Addendum No. 1
Page 1 of 2

TO: Prospective Bidders
SUBJECT: Addendum No. 1
PROJECT NAME: Parking Lot Improvements
JJC PROJECT NO.: B15001

DRAWING TITLE:
PARKING AREAS
E3 and E4

DRAWING No.:
 114-0964-E01C
 SCALE: AS NOTED
SHEET 3 OF 3

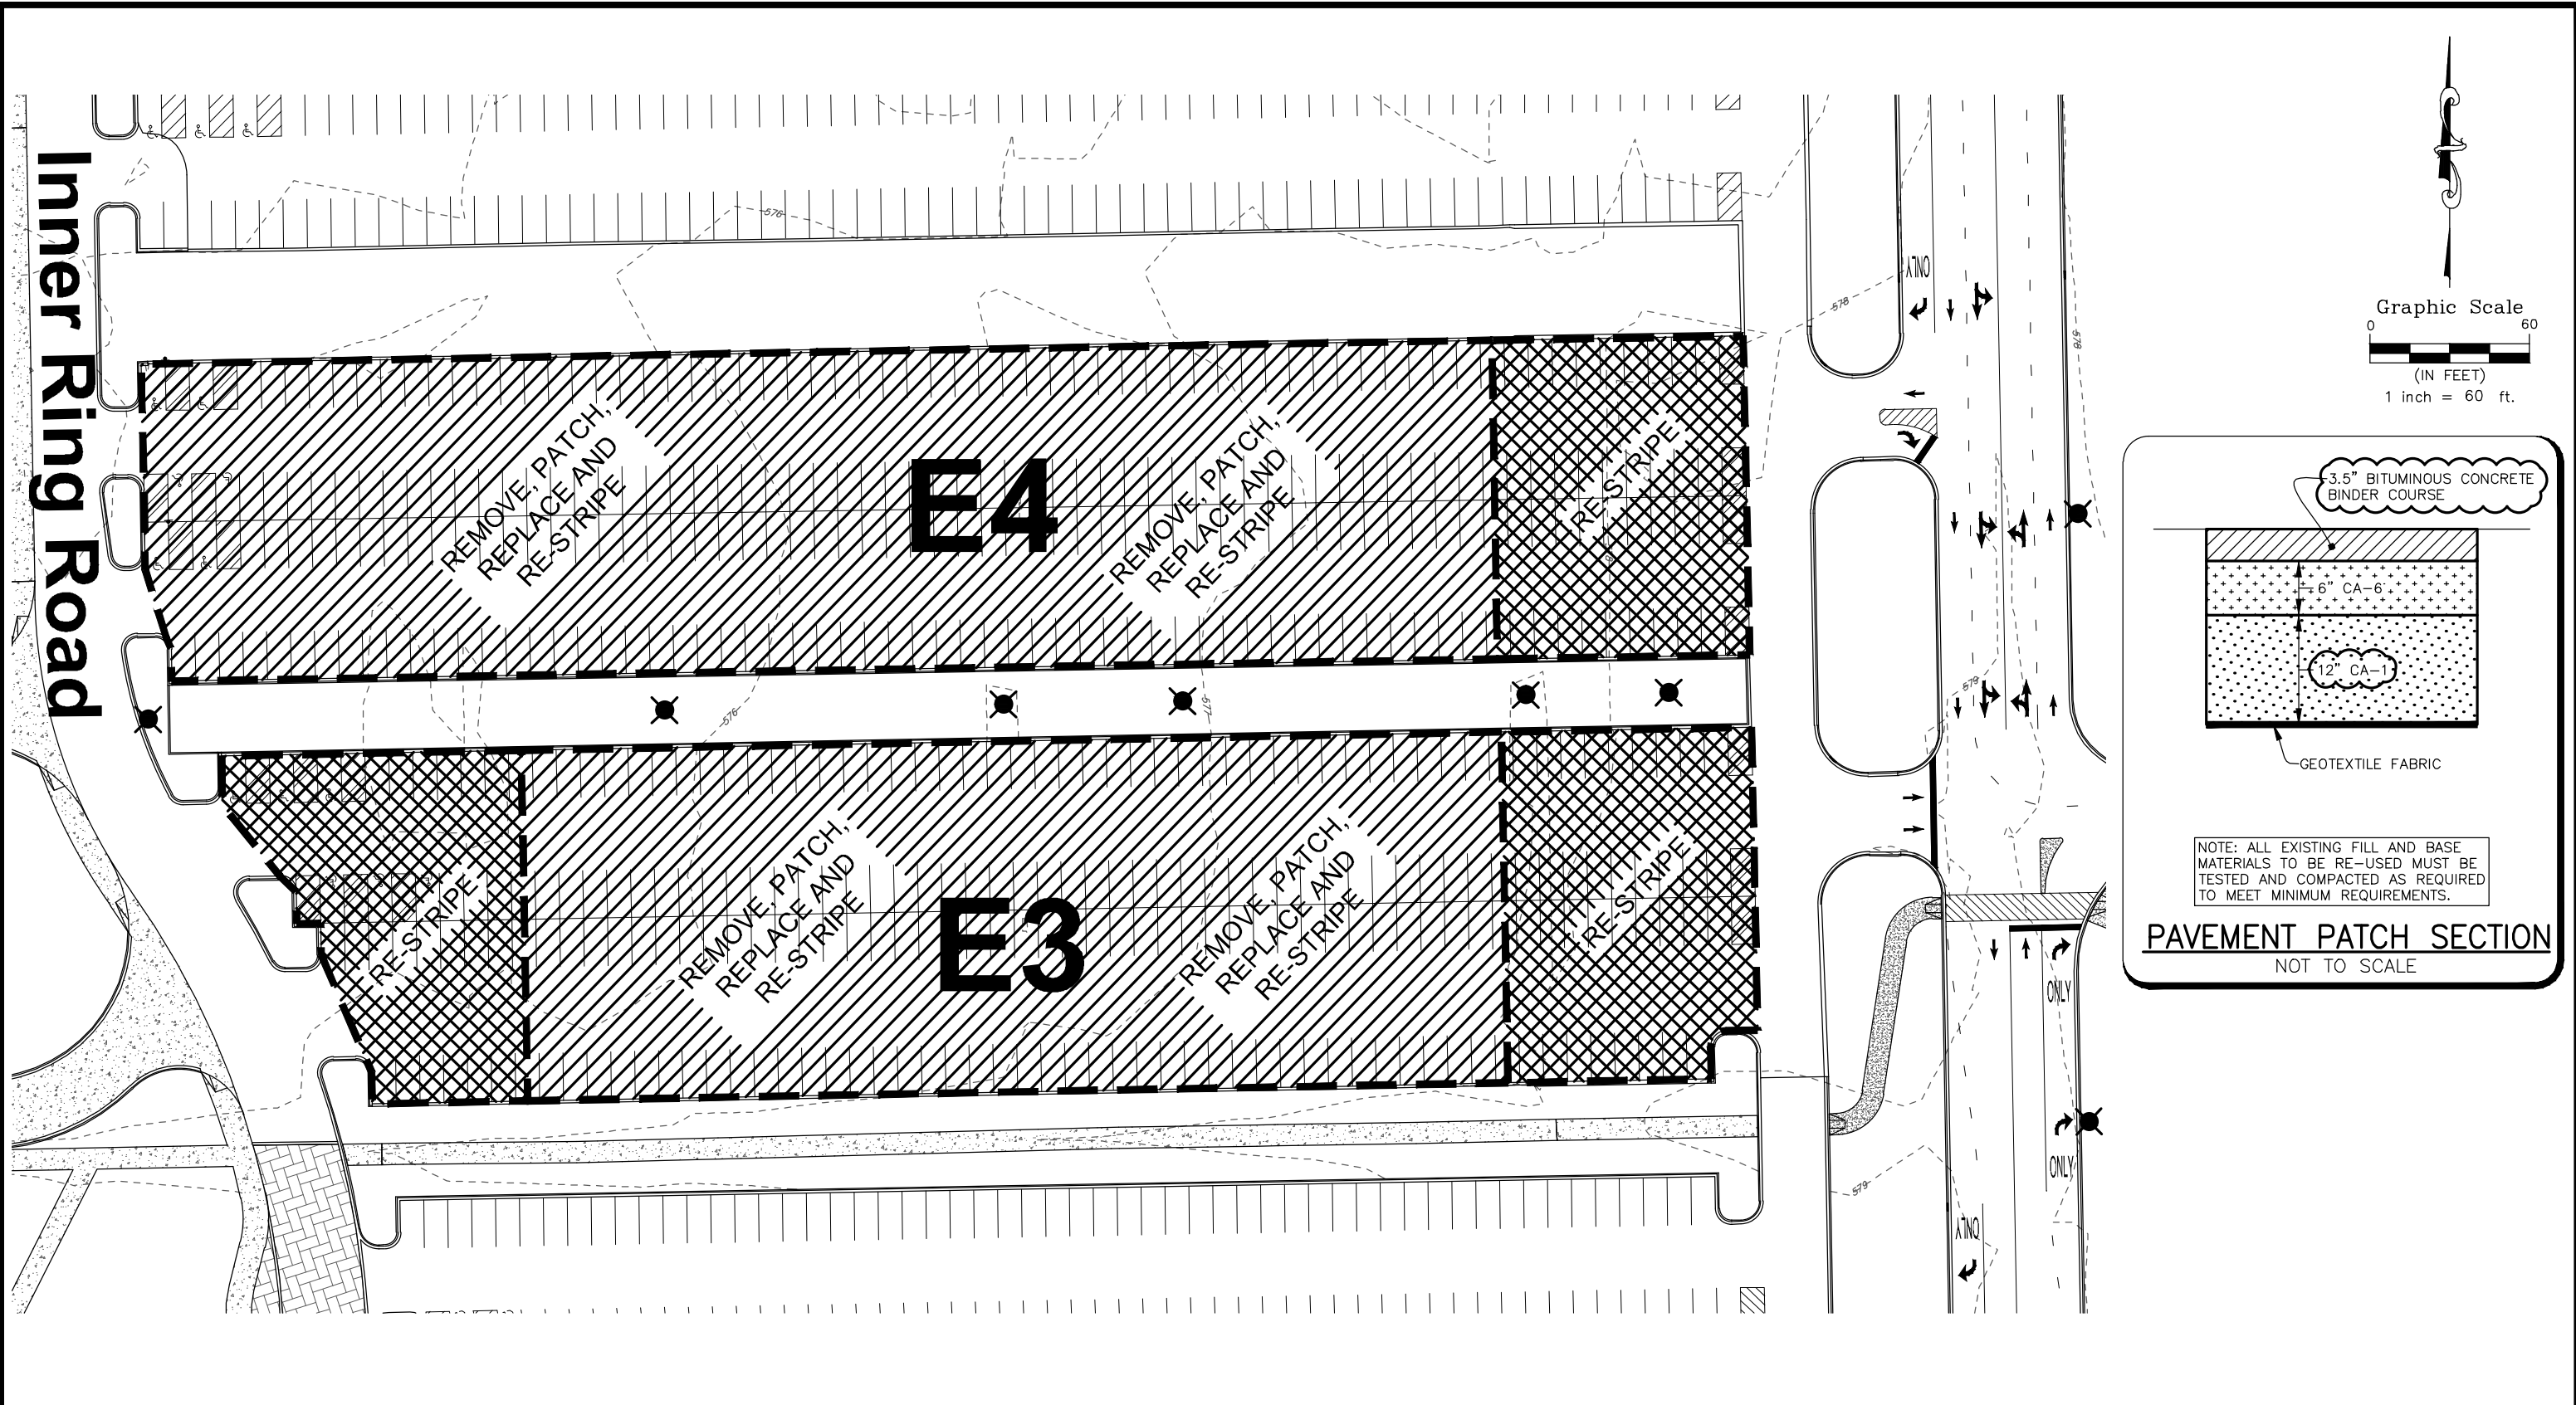
- A. Engineer will mark patching as needed anticipating the contractor to utilize a grinder for removal.**
6. You call out 12" of CA2, the quarries do not have the material I am assuming you are looking for 3" stone which would be CA1 and can we use binder for the 3.5" of asphalt, plans call out surface.

- A. The detail on Sheet 3 of 3 has been modified to describe the patch as geotextile fabric, 12" of CA-1, 6" of CA-6 and 3.5" of binder course.**

REVISIONS			
No.	DATE	DESCRIPTION	BY
1	2-04-15	CROSS-SECTION PER ADDENDUM 1	R.P.
